Notes for Harston residents interested in East-West Rail's proposals

The 2026 consultation

Here is a still from the video:

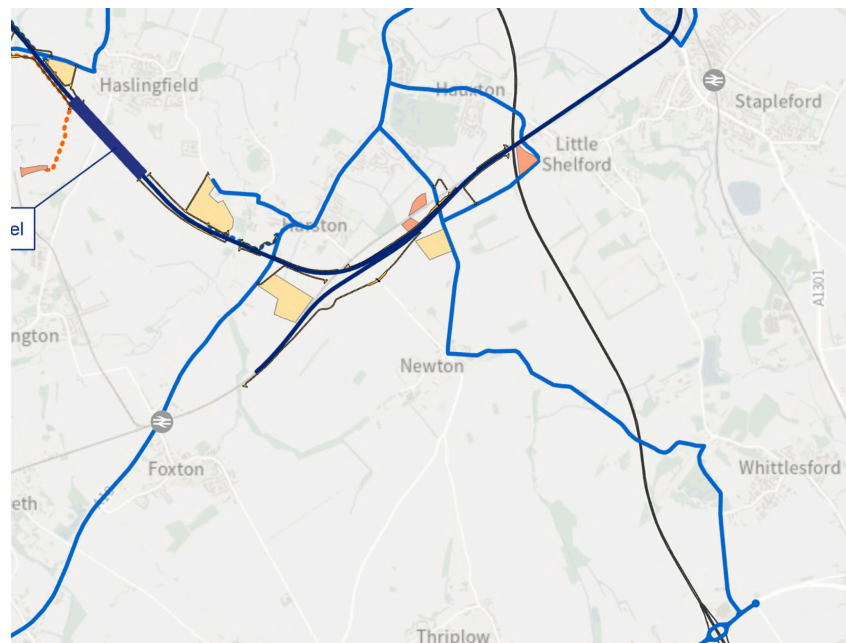
You can see they propose some earth banks for screening near to the tunnel exit.

Interestingly, they do **not** propose earth banks near to Harston.

Adding them to the proposed tree planting would reduce noise from the trains.
